SPECTRO3-SL-Scope: Changes due to software update from SPECTRO3-SL-Scope V1.1 to V1.2

This manual summarises the changes that were made with the software update from **SPECTRO3 SL V1.0** to **V1.2**.

Change 1:

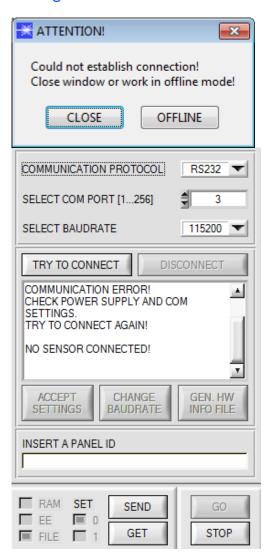
If a connection is not established automatically, e.g. if no sensor is connected, the software can be run in OFFLINE mode. In offline mode it only is possible to exchange parameters with a file on a storage medium, which often is helpful for the purpose of analysing parameter files.

If a sensor is connected and a connection still cannot be established, either the SCOPE version (program on the PC) and the firmware version (program in the sensor) do not match, or the interface to the sensor must be correctly configured.

If different Scope and firmware versions should be the problem, please get the Scope version that matches the firmware from your supplier.

Change 2:

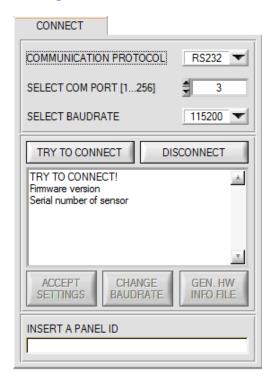
When a connection is established the serial number of the contacted sensor is transferred in addition to the firmware version

The baudrates have been extended with 230400 and 460800.

DISCONNECT disconnects the connection between sensor and PC. The software then switches to OFFLINE mode, where it is only possible to exchange parameters with a file on a storage medium.

The interface is then free for other programs (e.g. FirmwareLoader).
